SERVICE LETTER

SUBJECT: HARTZELL SERVICE BULLETIN HC-61-221, PROPELLER - INTRODUCTION OF A CYLINDER CLAMP

Appendix A to Pilatus Service Letter No. 024

Propeller - Introduction of a Cylinder Clamp

Cylinder Clamp Kit Components
Figure 1

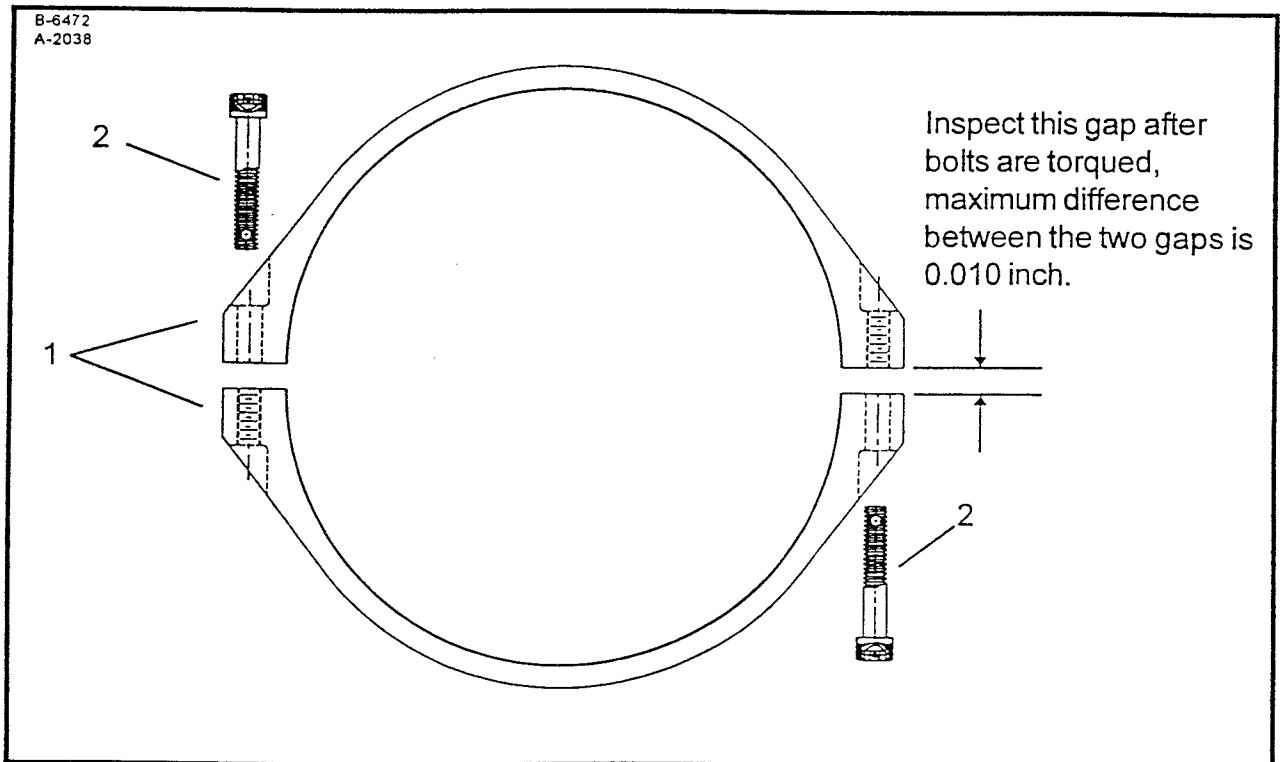
<u>Part Number</u>	<u>Description</u>	<u>Fig. 1/Item No.</u>	<u>Qty</u>
A-6525	Cylinder Clamp Kit	Reference	1
B-6472	• Cylinder Clamp	1	1
A-2038-12	• Bolt	2	2

- (9) Check the gap between the clamp and the hub. The gap between the cylinder clamp and the hub can be no greater than 0.145 inch as shown in Figure 9. Insure that there is an equal amount of gap around the entire circumference of the cylinder clamp.
- (10) Torque the cylinder clamp bolts to 47 - 52 in-lb (dry). Inspect the gap between the clamp halves while torquing the bolts. The difference between the two gaps must not exceed 0.010 inch. See Figure 1 for gap location.

Beta System Puller Installed
Figure 2

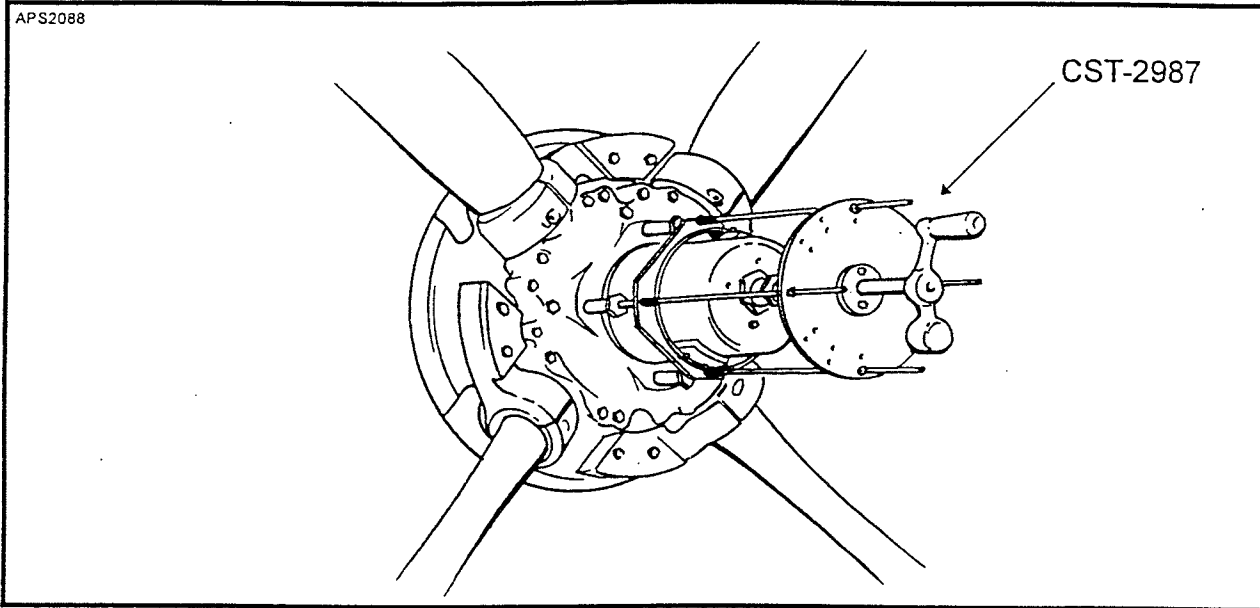
- (1) Remove the spinner dome and forward bulkhead in accordance with the airframe manufacturer's maintenance manual.
- (2) Install the CST-2987 Beta System Puller and pull the beta ring towards the hub flange. See Figure 2.

NOTE: The beta system puller is used to pull the beta yoke toward the end of the cylinder in order to provide clearance for installation of the cylinder clamp.

Cylinder Clamp Installation, Step 1
Figure 3

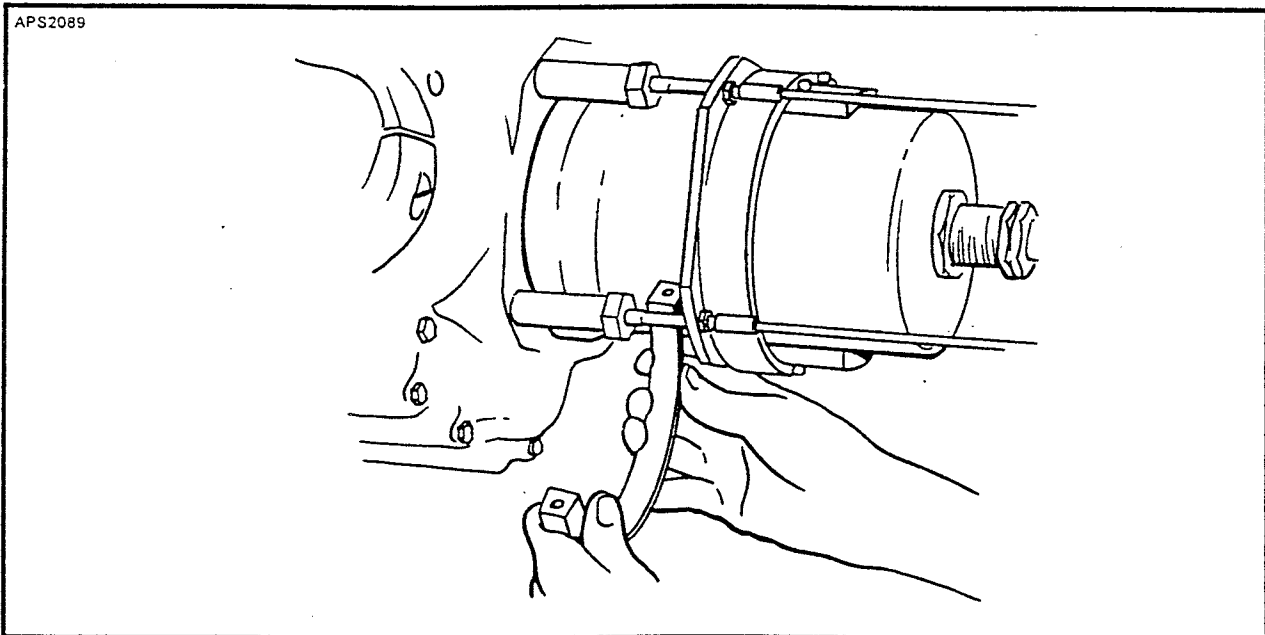
- (3) Insert one end of the cylinder clamp half between the beta rod and the cylinder of the propeller as shown in Figure 3.
- (4) Once the cylinder clamp half is installed between the beta rod and the cylinder (see Figure 4), rotate the cylinder clamp half until the open end is towards the cylinder as shown in Figure 5.

Cylinder Clamp Installation, Step 4
Figure 6

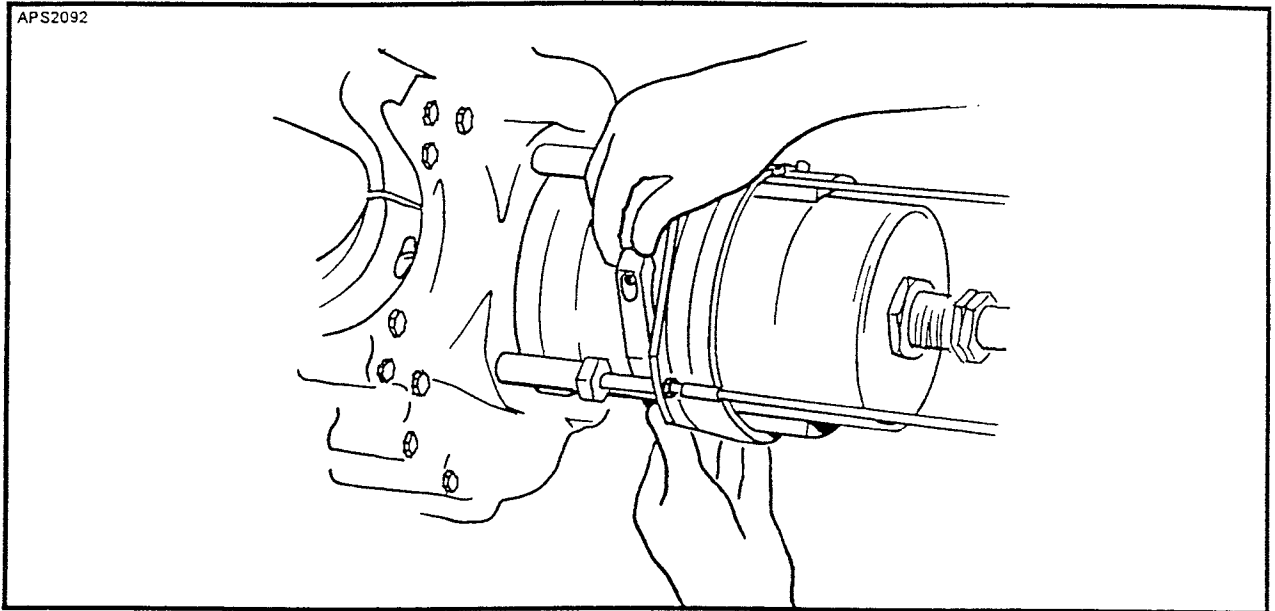
- (5) Position the cylinder clamp half so that the mating flange is centered between the beta rods as shown in Figure 6.
- (6) Move the cylinder clamp half to the base of the cylinder as shown in Figure 7.
- (7) Install the remaining cylinder clamp half onto the cylinder following procedures 3.B.(3) through 3.B.(6). The threaded end of one cylinder clamp half will align with the unthreaded half of the other cylinder clamp half.

Cylinder Clamp Installation, Step 6
Figure 8

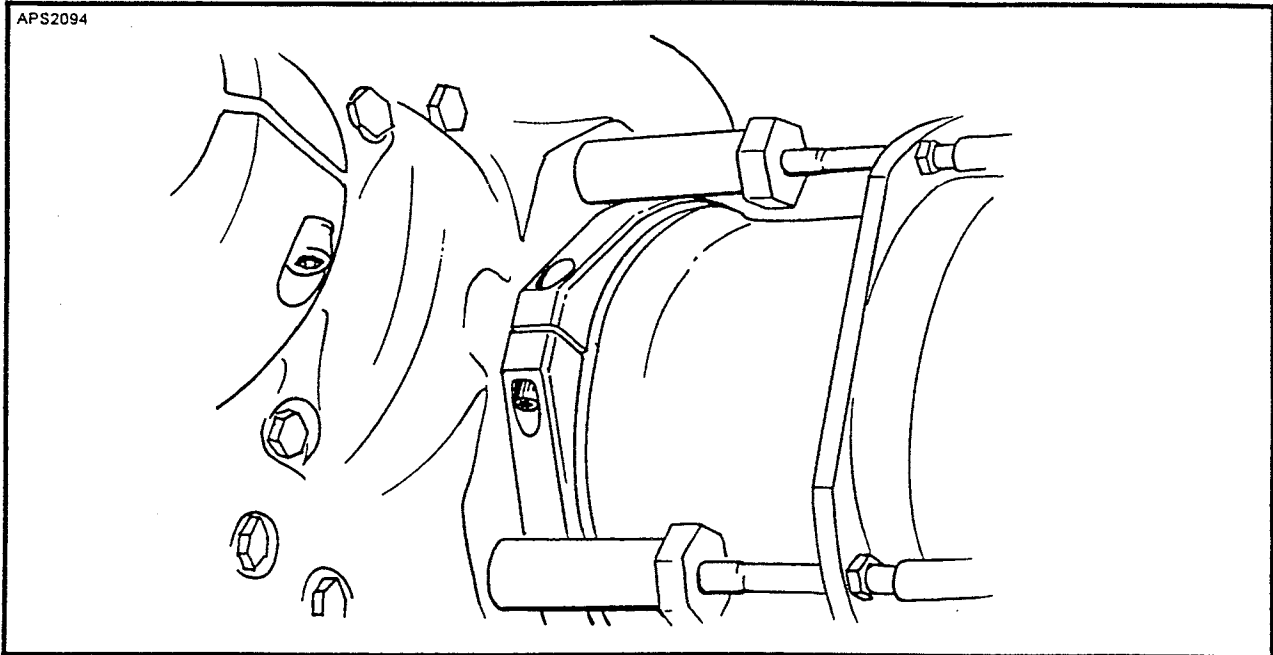
- (8) Install the cylinder clamp bolts in both clamp flanges and tighten until the clamp becomes snug on the cylinder. When installed on the cylinder, the cylinder clamp flanges should be centered between the beta rods and in contact with the hub as shown in Figure 8.
